# Memo

**Subject:** Private Plan Change 17 – Te Rapa North Industrial – Supplementary Technical Specialist Memorandum (Final - updated post hearing)

**Technical Area:** Transportation

Figure 2: Te Awa River Ride map shows on-road along Meadowview Lane<sup>20</sup>

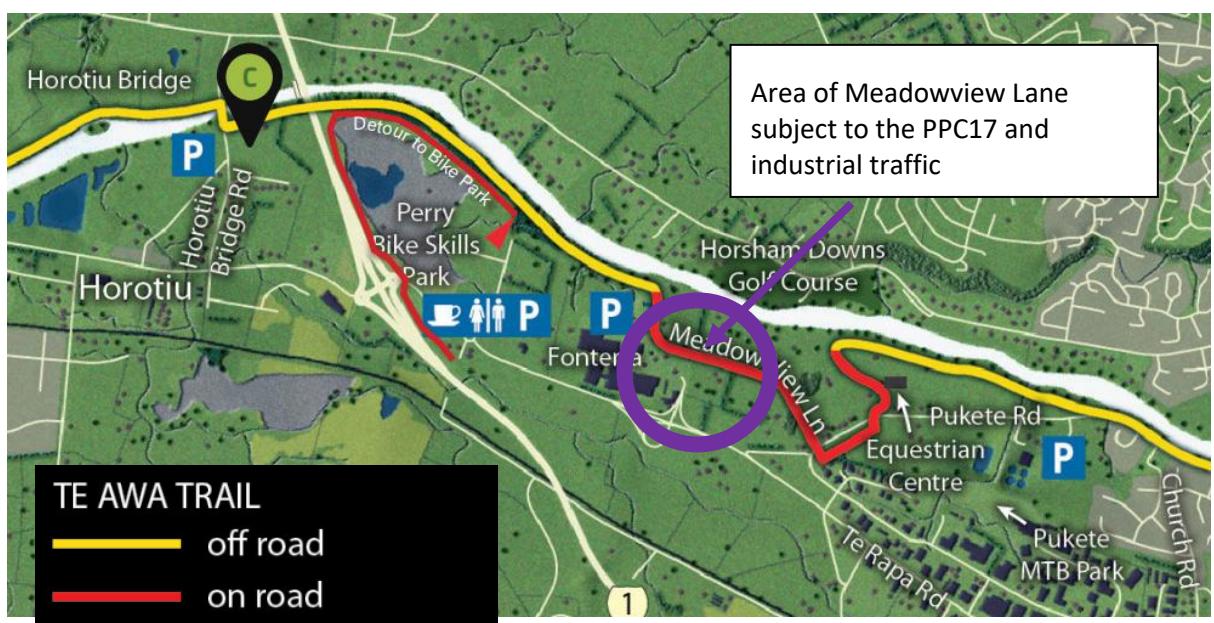
25. The Te Awa River Ride<sup>19</sup> currently utilises Meadow View Lane for on-road cycling access. It is not clear how safe public access for River Ride users will be maintained with the introduction of industrial traffic to the short section of Meadow View Lane.

26. In my opinion, it is undesirable for Te Awa River Ride cyclists to be mixing with industrial traffic along the northern section of Meadow View Lane. The cross-section of the affected Meadow View Lane should be upgraded to include a 3m wide off-road shared path on the east side.

Figure 3: Porters' land on the eastern side of the NIMT and suggested local road connections

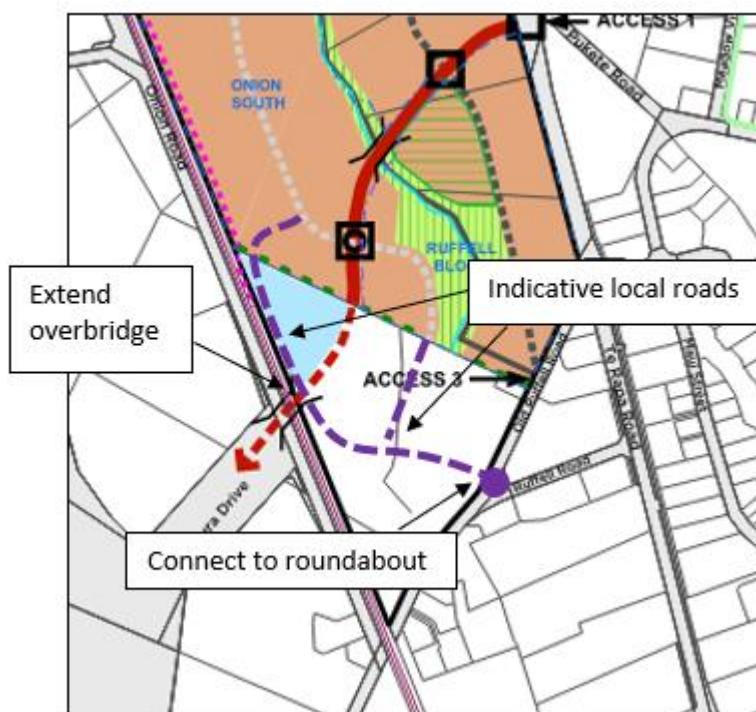
27. As stated in my addendum<sup>21</sup>, I consider that adopting the Porters' land in the triangle on the eastern side of the NIMT appears to be appropriate and feasible, however additional information and specific assessment is required to:
  - Confirm access arrangements. In my opinion, a fourth leg to the Old Ruffell Road/Ruffell Road roundabout would be suitable.

- Confirm building setbacks required to ensure adequate protection of the east-west road and future Northern River Crossing corridor (including space for the embankment). This is likely to require further assessment and engagement with HCC and KiwiRail.
- Confirm local road arrangements to access the land north of the east-west road. In my addendum<sup>22</sup>, I recommend a north-south local road be shown parallel to the NIMT to provide connectivity within the Porters' land.
- Confirm any new or amended provisions relating to triggers for Broad ITA and the proposed infrastructure upgrades triggered by cumulative net developable area.
